## PLAN COMMISSION

**Monday October 17, 2016**

**Agenda Item # 5 - General Plan – Redevelopment of former Beach House property and adjacent property immediately to the south**

Planned Development Infill District – General Plan - Waubesa Shores Apartments and Condominiums  
Statement of Owner's Intent and Description of Development:

SHEET  
1 OF 3

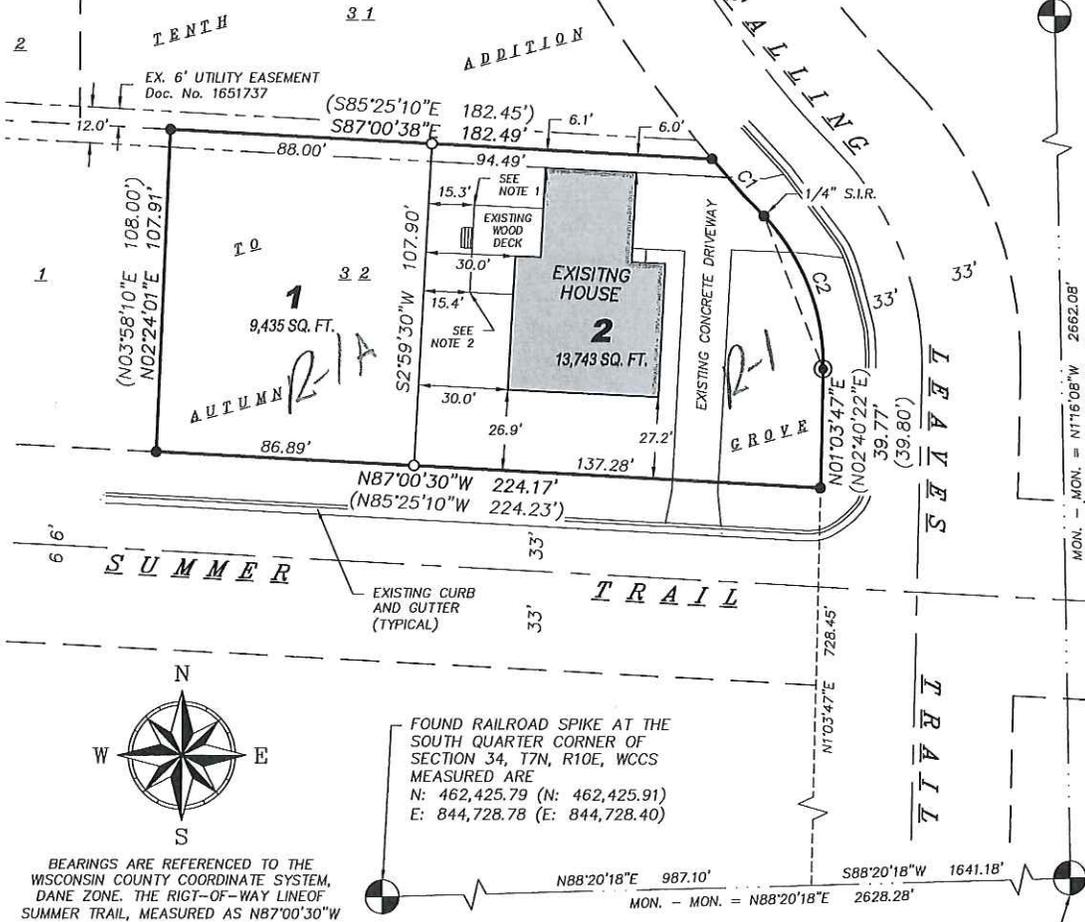
This item was postponed from our September meeting to obtain some clarification. Commissioners questioned the rear yard setback of Lot 1 given the existing rear deck. The property is zoned R-1 which requires a 30 foot rear yard setback. Our code allows for encroachments of decks less than 36” to no closer than 10 feet to the rear lot line. The CSM depicts an existing wood deck with heights of 20” and 17” above grade and over 15 feet from the rear lot line, which is compliant. Reducing the rear yard setback of Lot 2 to gain square footage for Lot 1 would result in reducing the required rear yard setback of Lot 2 to less than the required 30 feet. Property owners Cindy and Art Weber are requesting a rezoning of Lot 1 as it is 565 sq.ft. short of the 10,000 sq.ft. required for R-1 zoning.

EL01

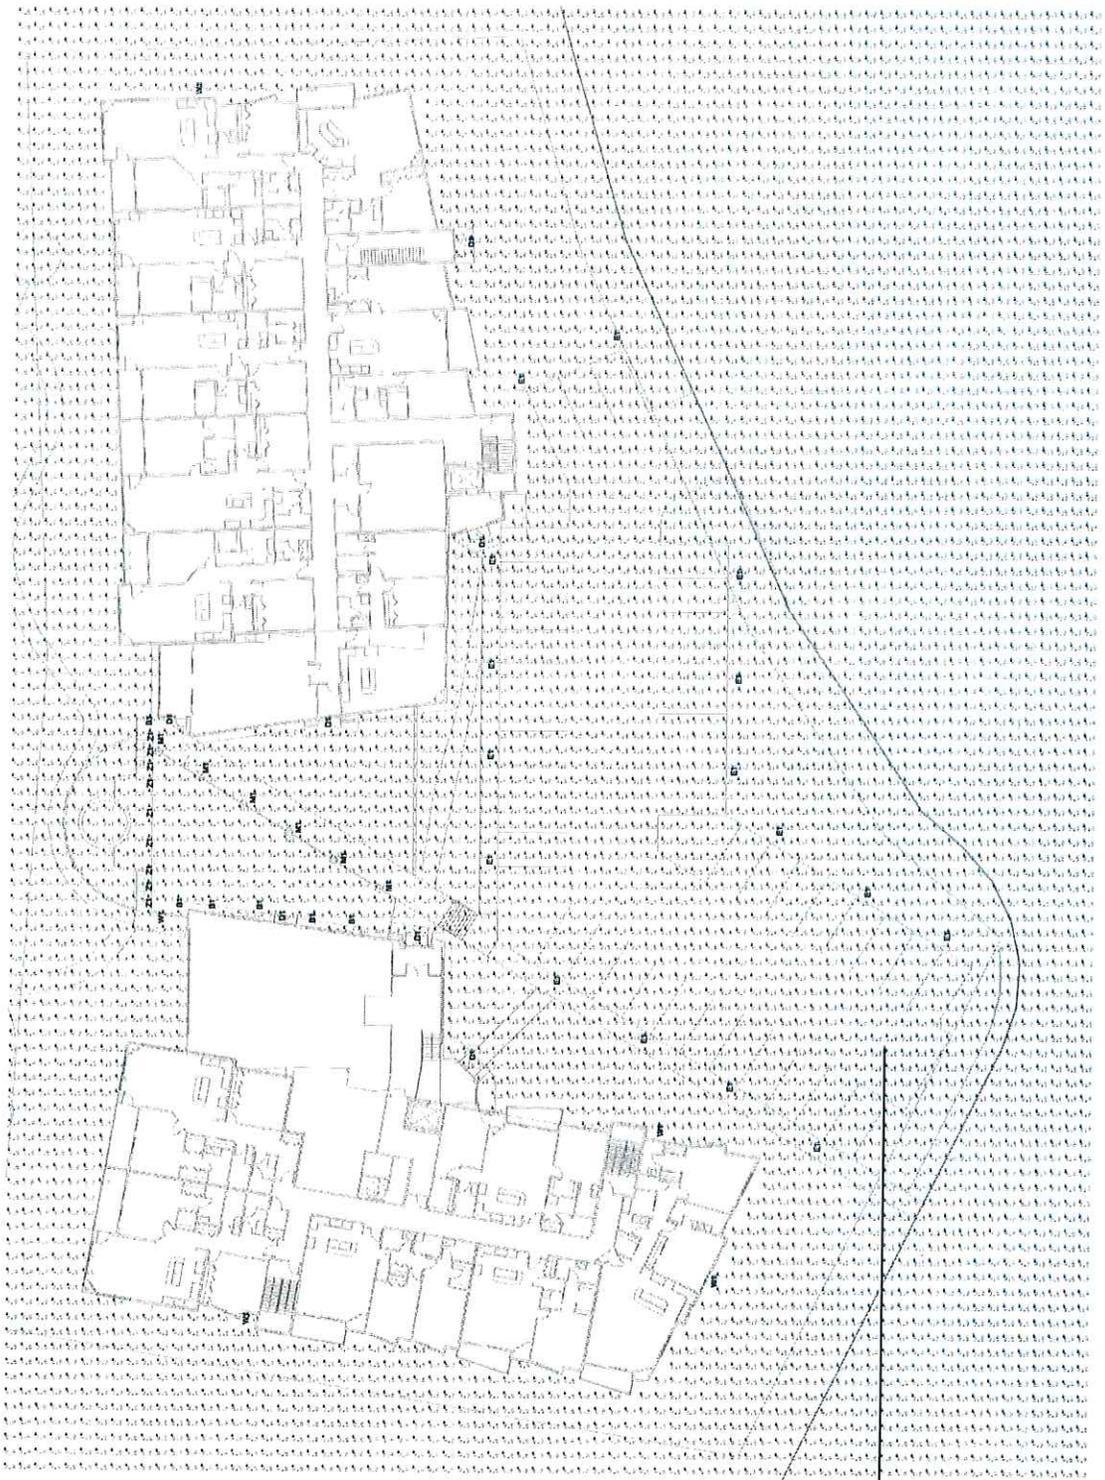
(7) Site lighting not to extend a direct light source onto abutting properties. Cut off type luminaires shall be used and all lighting shed shall be indicated on plans.

**Developers plan for lighting indicated minimal foot candles beyond site. Lighting fixtures appear to have shields.**

- No foot candles beyond site per Plan (greater setbacks will enhance this)
- Light fixtures selected have shields
- Light fixtures in side yards to be on motion detectors to reduce light towards neighbors.
- Meets Village ordinance requirements.
